Town of Parker Community Development Department  
Development Review Division  
Attention: **Stacey Nerger**

Application Type: **Subdivision**  
Status: **First Referral**  
Application Name: **Trails at Crowfoot F16**  
Case/AP#: **SUB20-040**  
Referral Received: March 3, 2021  
Comments Due: March 31, 2021

Review date: **March 12, 2021**  
Plan reviewer: **Randall L. Capra**, [rcapra@parkeronline.org](mailto:rcapra@parkeronline.org)  
Phone: 303.805.3168

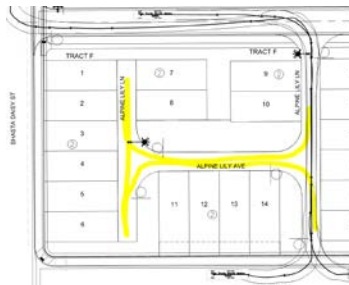
Note - Per the requirements of [18 IFC Appendix "D" Section D107.1] Developments of one- or two-family dwellings where the number of dwelling units exceeds 30 shall be provided with two separate and approved fire apparatus access-roads. This submittal does not meet the requirements of the code regarding access roads. Section D107.1 does have two exceptions with exception #1 applying as noted: Where there are more than 30 dwelling units on a single public or private fire access road and all dwelling units are equipped throughout with an approved automatic sprinkler system in accordance with Section 903.3.1.2, 903.3.1.2, or 903.3.1.3, access from two directions shall not be required."
